Wind Energy Explained Errata - Initial Printings

There are number of recurring errors that were introduced in the printing process. These fall in to two categories:

Figure 6.19 SERI airfoils, thin airfoil family (National Research Council, 1991)

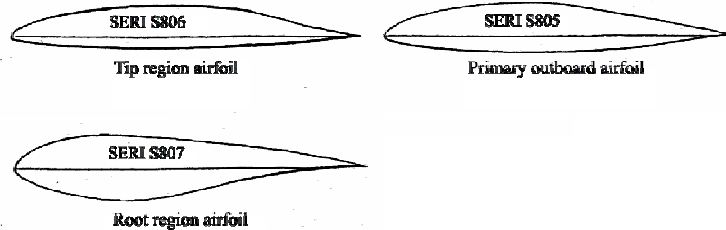
p. 289 Figure 6.19 - In the Figure the airfoil designations should read S806, S805 and S807:

Figure 6.45 Power curves

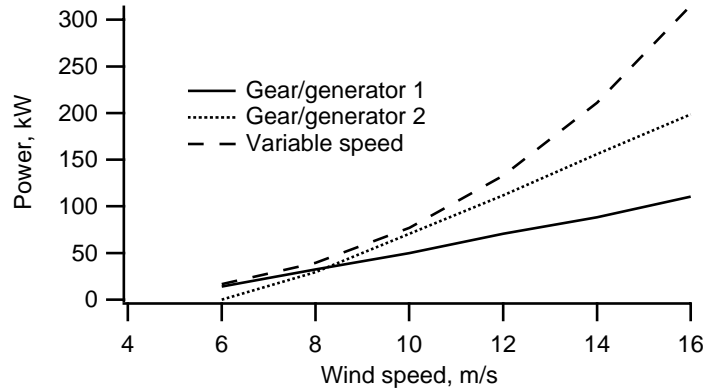
p. 316 The corrected Figure 6.45 follows:

Figure 7.1 Control system components

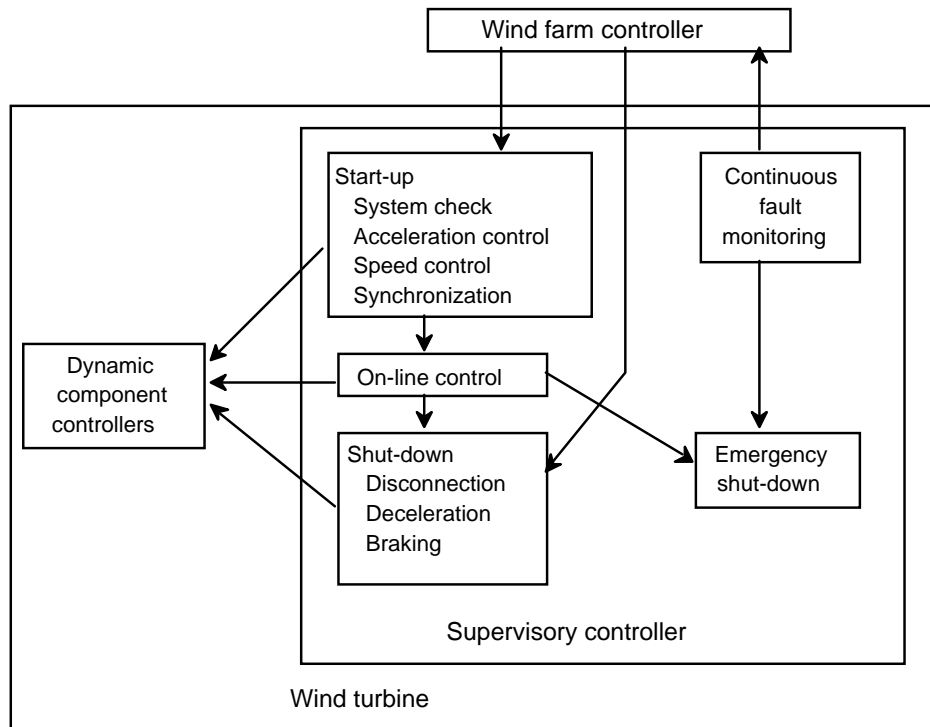
p. 322 The following Figure was misprinted:

Figure 7.25 Schematic of computer controlled system; A/D, analog-to-digital converter; D/A, digital-to-analog converter

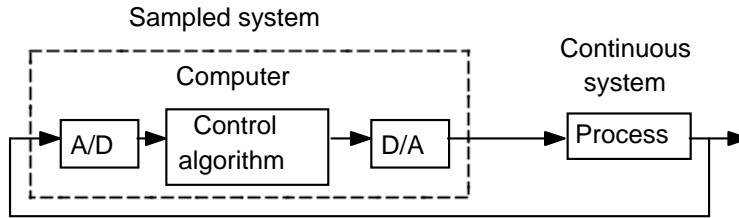
p. 366 The following Figure was misprinted:

Figure B.9

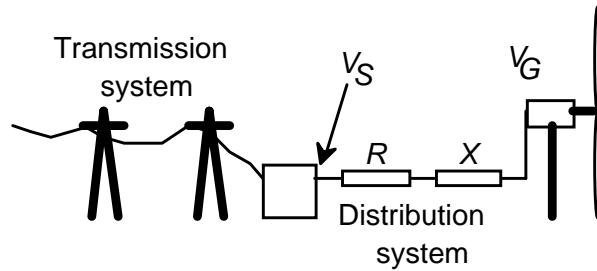
B.8.5 Grid Fault Level and Voltage Fluctuations

Consider a wind turbine generator connected to a grid system (see Figure B.9) with a line-neutral system voltage, V_S . The voltage at the wind turbine, V_G , is not necessarily the same as V_S . The distribution system resistance is R, and the distribution system reactance is X.

The real generated power is P and reactive power consumed by the wind turbine generator is Q . Suppose $R = 8.8 \Omega$, $X = 4.66 \Omega$, $V_S = 11 \text{ kV}$, $P = 313 \text{ kW}$, $Q = 162 \text{ kVAr}$ and the power factor at the generator is $\text{pf} = 0.89$. Determine the voltage difference between the grid and the generator, the voltage drop as a percent of the grid voltage, the fault level at the generator and the installed generator capacity as a percent of the fault level.
